TRANSPORT AND WORKS ACT 1992
TRANSPORT AND WORKS (INQUIRIES PROCEDURE) RULES 2004
PROPOSED NETWORK RAIL
(STALYBRIDGE TO DIGGLE (SADDLEWORTH) ENHANCEMENTS) ORDER

Proof of Evidence

Peter Simpson MEng GMICE

Canal & River Trust

Fig. 1 Tunnel at approximately 130m from the Diggle Portal

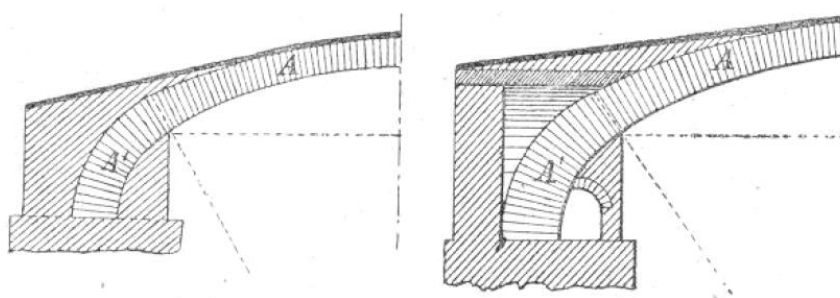
4.10. In my opinion the approach to date from Network Rail seems to be that of tackling this as work to a road bridge and not what it is, which is works to a tunnel with no current live loading to the structure (albeit with a similar construction as an arch bridge). Both Network Rail's previous saddling proposal and their currently proposed relieving slab options are standard bridge solutions making use of the existing structure. Network Rail have also been making the assumption that the tunnel side walls in the section of tunnel just along from the location of the proposed relieving slab, i.e, where the railway crosses the tunnel are the same as the tunnel side walls in the location of the proposed relieving slab.

4.11. At the location where the railway line crosses the tunnel, this section of tunnel has historically always been of a different construction, previously wrought iron or early steel girders, which at some point has been replaced by a reinforced concrete slab. Whereas the location of the proposed relieving slab has always had a brick arch which has as far as we are aware remained unchanged since construction of the tunnel extension. Network Rails assumption that the side walls in the section of tunnel of tunnel below the railway are the same as the side walls in the section of tunnel in the location of the proposed relieving slab is quite a big assumption to take, especially as historic tunnels tend to have variations in barrel/wall thicknesses along their length even if there is no obvious difference in construction. It is also noticeable that the side walls are taller under the flat deck sections compared to the arch section along this length of tunnel as shown in images below.

Fig. 5 Photograph of haunching at a canal arch bridge

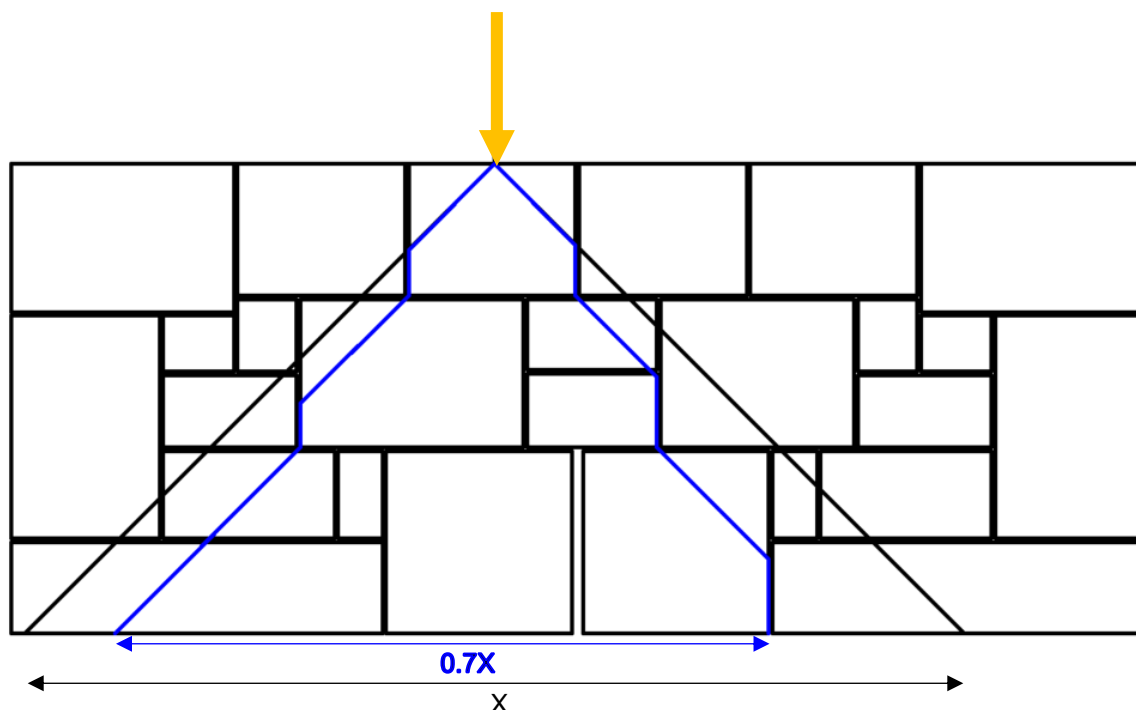
4.12. Within the proposals from Network Rail to date the saddling proposal implied there was likely backing/haunching behind the arch and the relieving slab proposal implied there was no backing/haunching. But I am not aware of any works having been undertaken to prove or disprove the presence of any backing/haunching. However, the presence of angled backing/haunching will have an impact on the suitability of the slab and how the vertical loads will be transferred into the abutment and if any works are required to the canal tunnel to facilitate the installation of the slab. (See the figure below which shows typical back profiles and the photographs below that show haunching of an arch.)
